1969 - 1976 Corvette: Service Bulletin: Air Conditioning Compressor Drive Belt to Radiator Hose Interference

Subject: Air Conditioning Compressor Drive Belt to Radiator Hose Interference

Model and Year: 1976 and Past Model Corvette Equipped with the 350 Cubic Inch Engine and Air Conditioning

Bulletin Number: 76-T-21, Section VI - (May 1976)

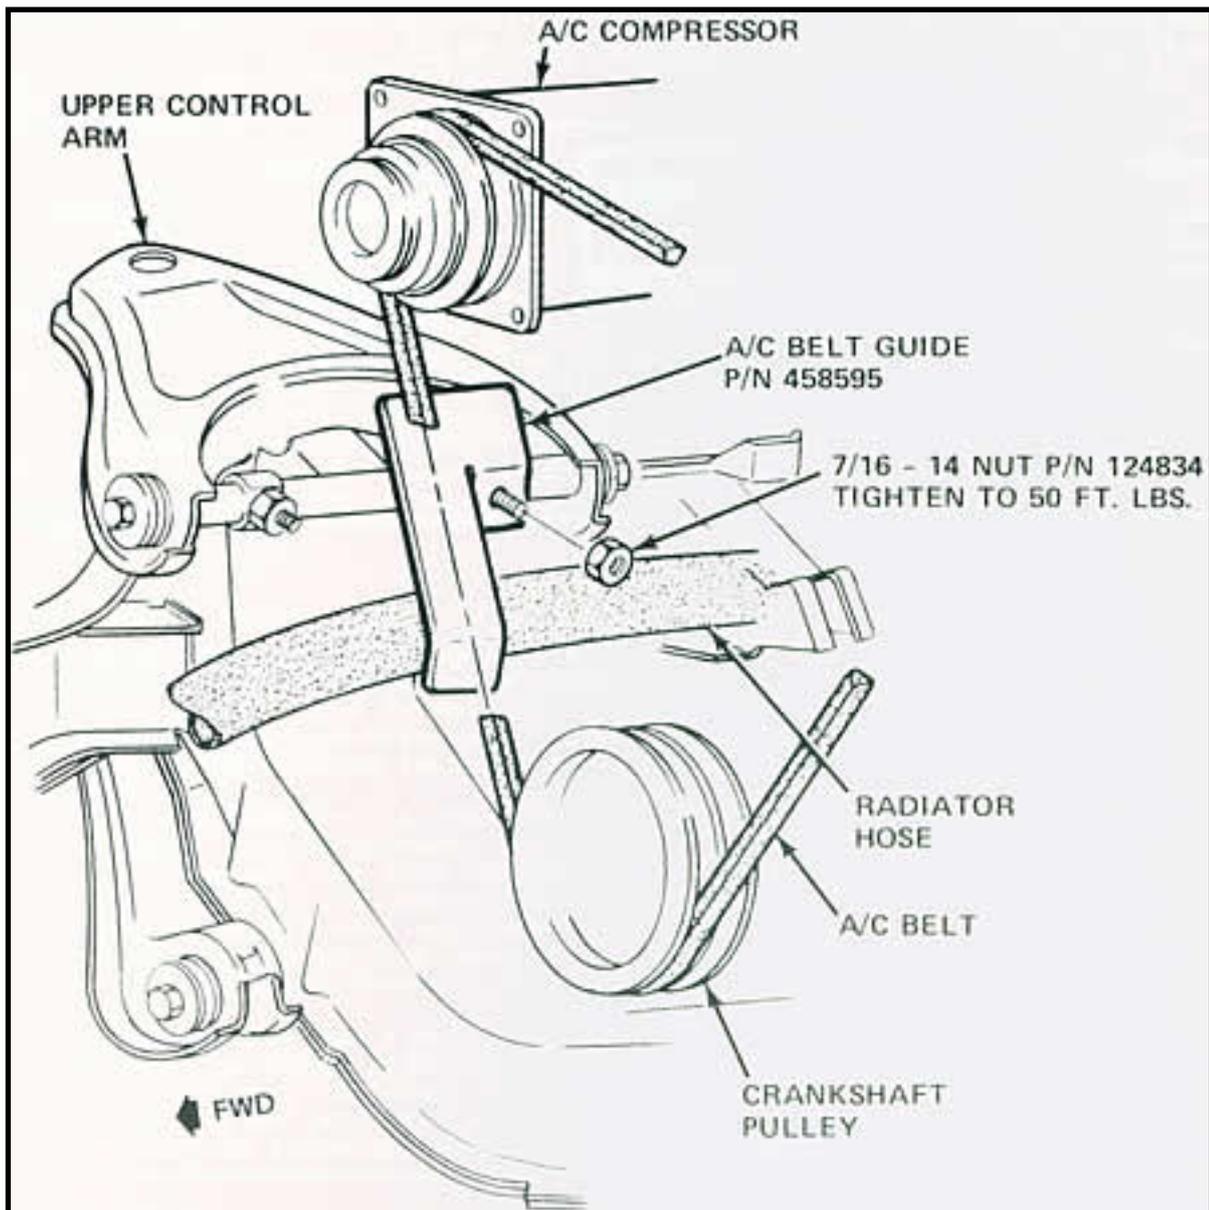
Some 1976 and past model Corvettes equipped with the 350 cubic inch engine and air conditioning may experience an interference condition between the radiator outlet (lower) hose and the air conditioning compressor drive belt. This belt chafing condition could damage the hose and may cause eventual coolant loss.

Belt to host interference has been eliminated by installing a belt guide, part number 458595, at the assembly plant. This guide is mounted over the rear attaching bolt for the upper right side control arm. The guide is between the belt and hose and prevents the belt from chafing the hose (see illustration on the following page). The belt guide went into production on vehicle identification number 6S416060 December 18, 1975.

This condition can be corrected on past model and vehicles built prior to the VIN cutoff by installing the belt guide as shown on the illustration. The belt guide can be obtained from GMPD. Use nut, part number 124834, to attach guide over the top of the existing rear upper control arm nut and torque to 50 ft.-lbs.
